PLANNING COMMISSION AGENDA

STAFF REPORT FOR THE PLANNING COMMISSION

TOWN OF SILVERTON HISTORIC REVIEW COMMITTEE BUILDING FAÇADE OF THE OUTDOOR WORLD BUILDING

Proposed Windows on the Façade of an Existing Building in the Historic Overlay District, Existing Outdoor World Building, 1234 Greene Street, Lot 7, Block 20, Silverton, Colorado.

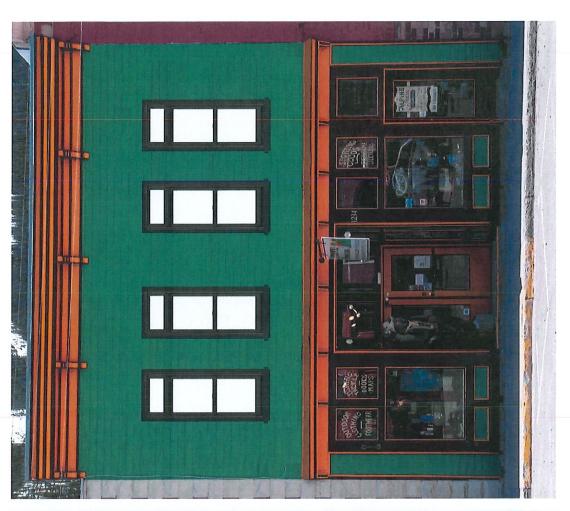
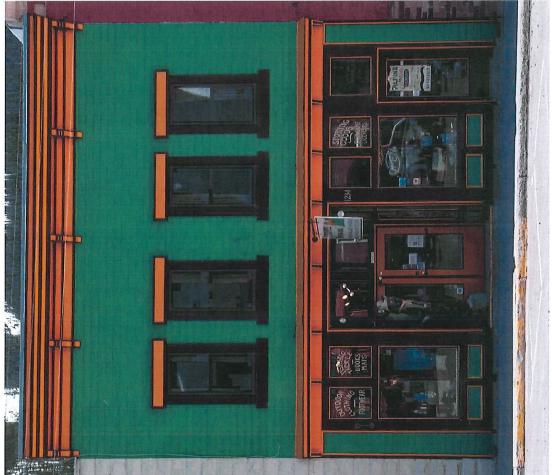
The Before photo (included in the attached submittal) shows a horizontal, decorative, painted wood, window trim board, over each of the four windows. I believe the decorative horizontal wood trim over the existing windows might be called a "pediment." A "lintel" seems to be more structural like a header. The After photo (included in the attached submittal) shows a proposed upper, transom piece of glass, where the existing painted wood trim board is located. The Planning Commission may wish to discuss with the Applicant if that existing decorative trim might be, or should be, reattached at the top of the new windows.

We would like to replace the upstairs windows on the Greene Street frontage. We would like to increase the height of the windows from 5 feet to 7 feet, keeping the same width of the current window frame. Attached are before and after comparisons.

There were no Town regulations or design guidelines encountered which would prevent you from approving this project. The Planning Director recommends that you can approve the four proposed windows.
